**SUBDIVISION,
PLANNED UNIT DEVELOPMENT, &
SIDEWALK WAIVER STAFF REPORT****Date: September 15, 2022****APPLICANT NAME**

Dawes Townhomes Subdivision

CONTEMPLATED USE

DETAIL SITE PLAN

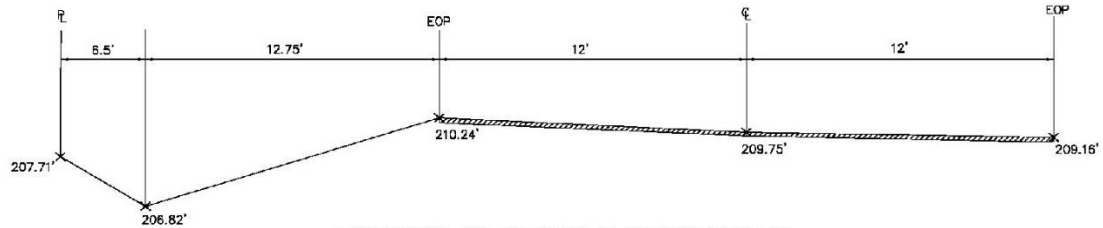
It appears that there is sufficient room within the ROW, or within the property, for the construction of a sidewalk that could be permitted.

TYPICAL SECTION DAWES ROAD
N.T.S.

TYPICAL SECTION GLIDER AVENUE
N.T.S.

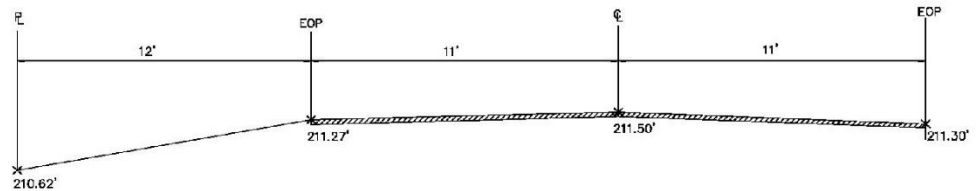
It appears that there is sufficient room within the ROW, or within the property, for the construction of a sidewalk that could be permitted.

- 2) *The properties along Glider Ave that are adjacent to our property do not contain sidewalks. If we were to propose a sidewalk along our property line then there would be inadequate pedestrian flow from our property to adjacent properties, thus preventing a need for a sidewalk to be placed along our property line.*
- 3) *We are not proposing a connection to Old Government Street and the adjacent properties along Old Government Street do not contain sidewalks. If we were to propose a sidewalk along our property line then there would be inadequate pedestrian flow from our property to adjacent properties, thus preventing a need for a sidewalk to be placed along our property line.*

TYPICAL SECTION OLD GOVERNMENT STREET
N.T.S.

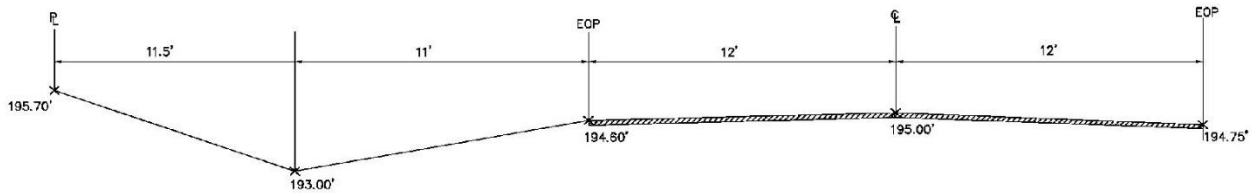
It appears that there is sufficient room within the ROW, or within the property, for the construction of a sidewalk that could be permitted.
